**Monks Orchard Residents' Association
Planning**

Reference	19/04705/FUL
Application Received	Wed 02 Oct 2019
Application Validated	Wed 02 Oct 2019
Address	16-18 Ash Tree Close Croydon CR0 7SR
Proposal	Demolition of the existing dwellings. Erection of 8 x 3-bed semi-detached dwellings with associated access, parking, refuse and cycle stores.
Case Officer:	Wayne Spencer
Consultation Close:	Wed 30 Oct 2019
Deadline determination:	Wed 27 Nov 2019

Swept Path Egress Diagrams:

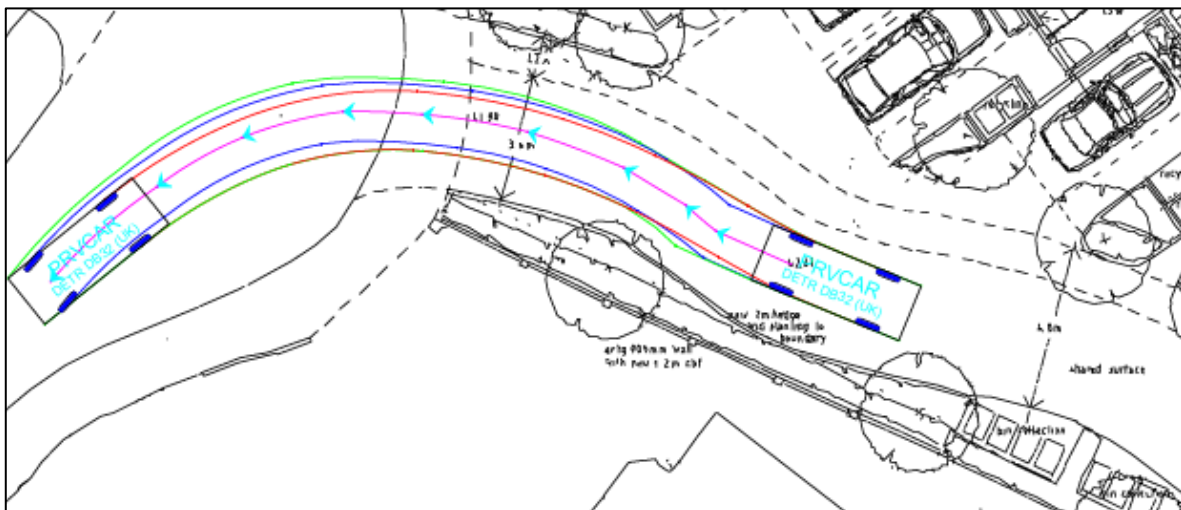
The "Swept Path Diagrams" provided with the documents associated with the proposed development give an indication of the entrance to park in the Plot Bays in a forward gear and also the swept paths necessary to exit the plot bays and change into a forward gear to exit safely across the access footpath and drop-kerb into Ash Tree Close. An analysis of these swept path manoeuvres are given below.

Any vehicle (delivery vehicle etc) which accesses the new driveway in a forward gear and finds all parking bays full, has **NO** turning head to allow exiting in a forward gear across the footpath of **Ash Tree Close**. This results in an **extreme safety hazard** to possible pedestrians using the footpath.

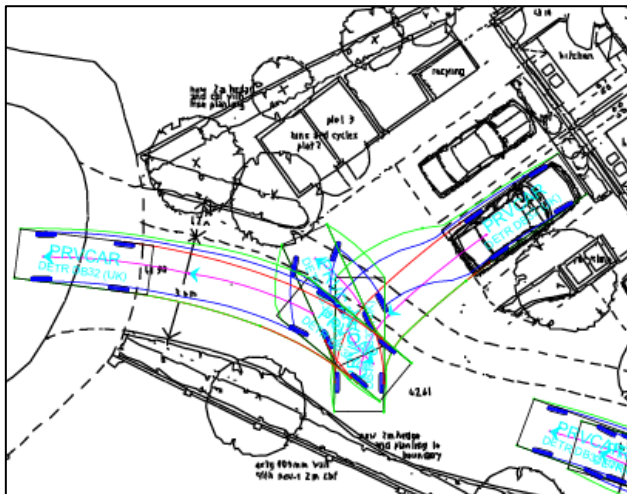
The only solution is to Reverse into the driveway but that might not be considered by the driver before actually entering the driveway and once entered in a forward direction, the driver would have to **reverse** out and may not have a passenger to assist in the manoeuvre **to check it is clear and safe to reverse** out across the footpath of **Ash Tree Close**.

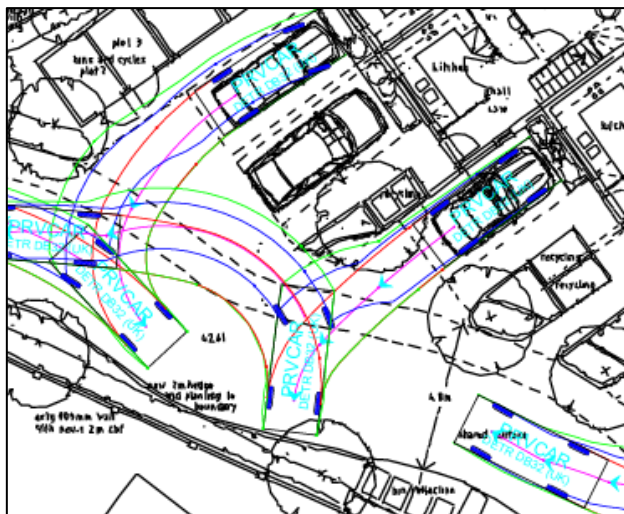
Plot 2 Parking Bay Egress Swept path diagram indicates the difficulty exiting the parking bay in reverse gear in order to exit the driveway in a forward gear into Ash Tree Close roadway.

It is not clear how many forward and reverse shuttles are required to allow clear exit in a forward gear but from the swept path diagrams it requires quite a few. It is feasible that a driver would reverse out over the footpath (extremely dangerous) rather than attempt the manoeuvre as depicted in the swept path diagrams.

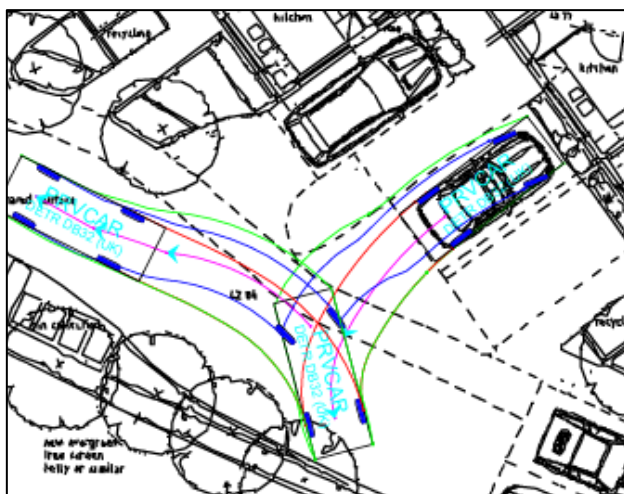
Plot 3 Parking Bay Egress Swept path shows that it is necessary to encroach over the **curtilage** of **Plot 2 frontage** and the **footpath** in front of **Plot 2** in order to exit in a forward gear – after driving into the parking bay in a forward direction.

This is not a manoeuvre which would be acceptable to the future owners or occupiers of **Plot 2** and could conceivably be a cause of future conflict between owners or occupiers and should therefore be avoided as a planning issue for the life of the development.

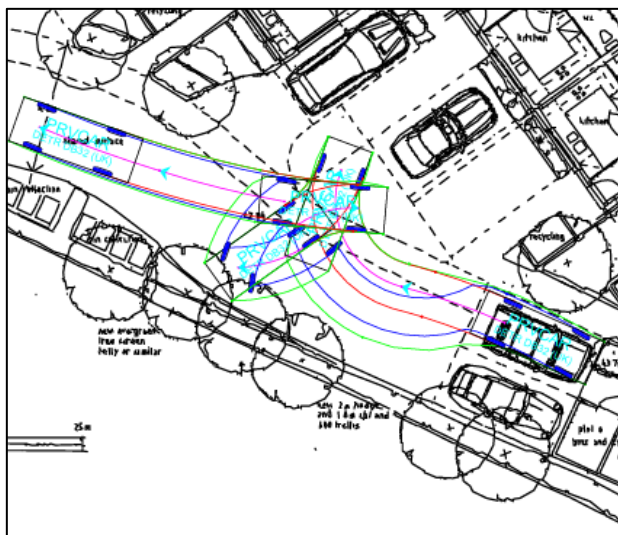
Plot 5 Parking Bay Egress Swept path shows that it is necessary to mount the new footpath to exit in a forward gear and would slightly encroach on the footpath of **Plot 4**.

This is not a manoeuvre which would be acceptable to the future owners or occupiers of **Plot 4** and could conceivably be a cause of future conflict between owners or occupiers and should therefore be avoided as a planning issue for the life of the development.

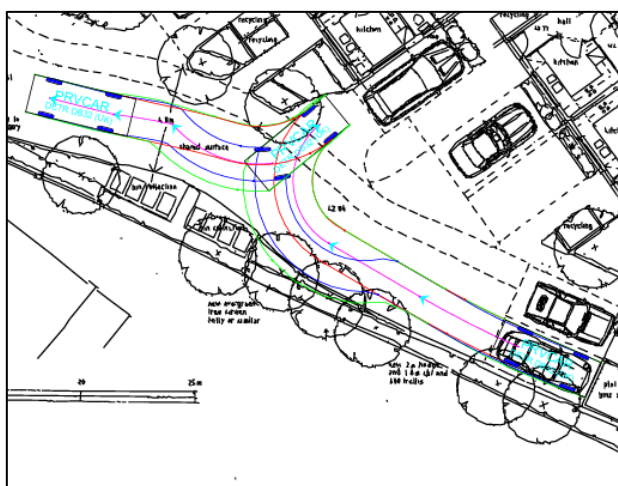
Plot 7 Parking Bay Egress Swept path shows that it is necessary to mount the new footpath and forecourt which are within the **curtilage** of **Plot 4 & 5** in order to have numerous difficult shuffles, backwards and forwards before exiting in a forward gear.

This is **not** a manoeuvre which is likely to be acceptable to the future owners or occupiers of **Plots 4 & 5** and could conceivably be a cause of future conflict between owners or occupiers and should therefore be avoided as a planning issue for the life of the development.

Extent of Flood Risk at proposed development site

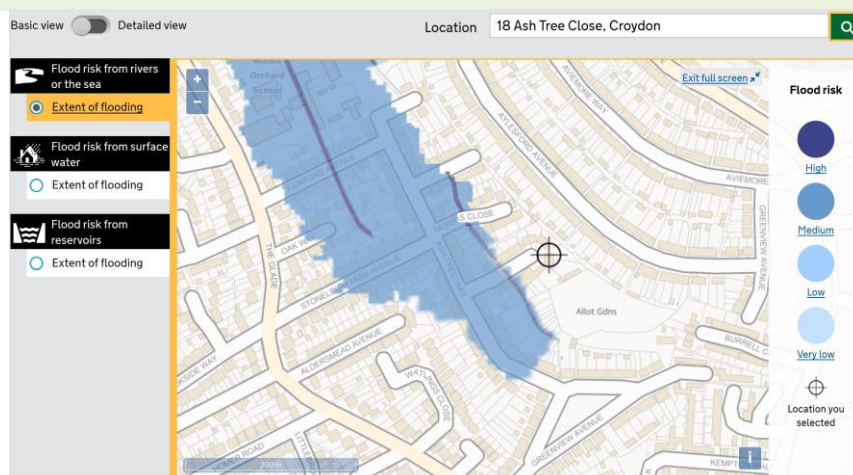
As there are real problems in the lower end of Ash Tree Close and Ash Tree Way, any future development planning at this locality would need to take surface water flooding seriously into consideration.
